CENWS-OD-TS-DMMO

MEMORANDUM FOR: RECORD **September 6, 2011**

SUBJECT: DETERMINATION REGARDING THE SUITABILITY OF PROPOSED DREDGED MATERIAL FROM LAKESHORE MARINA IN DON MORSE PARK, CHELAN WASHINGTON FOR BENEFICIAL RE-USE WITHIN LAKE CHELAN.

Figure 2. Sample locations, Don Morse Park.

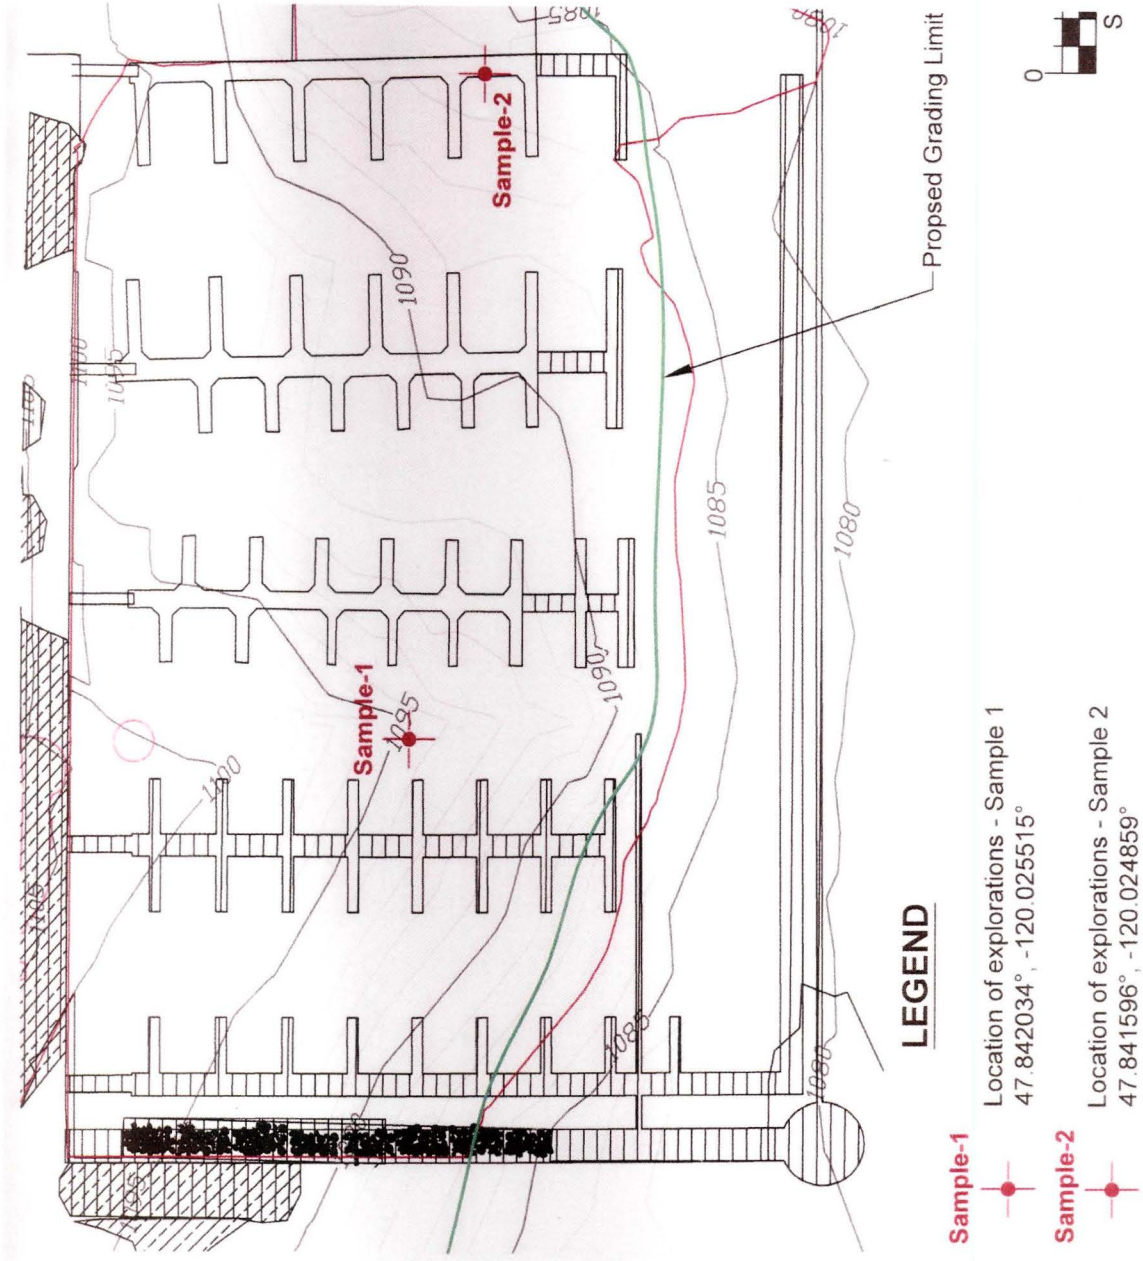
5. **Sampling**. Sampling took place on March 21, 2011. Sample cores were taken from two locations. The upper four feet from each sample location was composited for DMMU 1 and the lower portion of each sample was composited for DMMU 2 (Figure 2). Z-samples were collected from each sample location and archived.
